Lancashire County Council Update to the Parish Main Street, Warton

Preliminary proposal for No Waiting at Any Time Restrictions

DYL/ Conservation line comparison

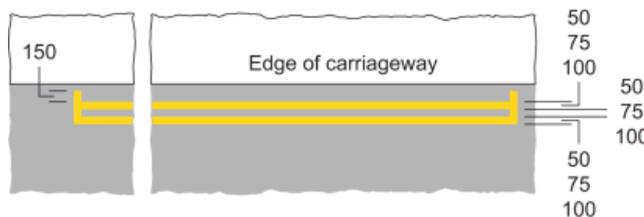
Q1. Won't double yellow lines will look unsightly and spoil the aspect and village character. The village is also in a conservation area?

The county council fully recognises local concerns and understands that it is vital to protect the character and attractiveness of its historic rural villages.

It would therefore be proposed to use 'conservation' double yellow lines in 'Primrose yellow'. Each line is marked 50mm narrower than normal double yellow lines used in urban areas and have been introduced successfully in a number of other areas.

Please see diagram below and photo showing where a road was resurfaced, and new conservation type lines have been installed in comparison to standard double yellow lines.
